Mitsubishi Motors North America, Inc.
TECHNICAL SERVICE BULLETIN

**NOISE FROM BRAKE CALIPER WHEN BRAKING
OR CORNERING**

No: TSB-24-35-001

Version: 3

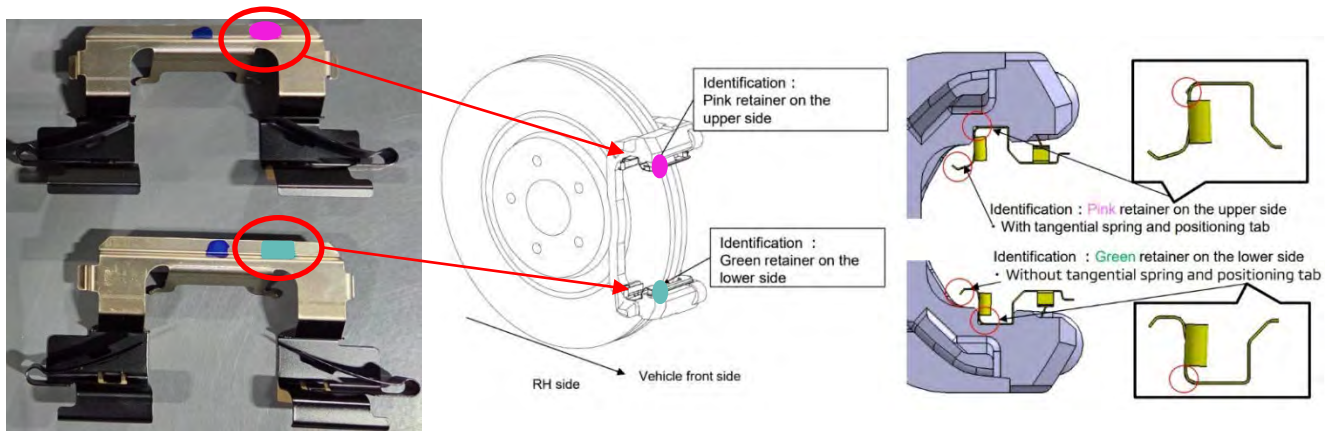
It is imperative to perform thorough cleaning of brake dust from the brake caliper bracket, as its essential to ensure proper adhesion of the new brake pad retainers to the brake caliper bracket.

Note: The brake pad retainer shapes differ between the upper (Pink dot) and lower (green dot), refer to the pictures in the parts information section in this document, ensure proper installation.

If the front brake disc(s) is damaged due to the interference of the brake pad retainers, perform an on-car lathe resurfacing procedure according to the brake disc usage limit parameters. If the brake disc wear limit is exceeded (27.4mm, 1.079in) replace the brake disc(s) in conjunction with the brake pad retainers.
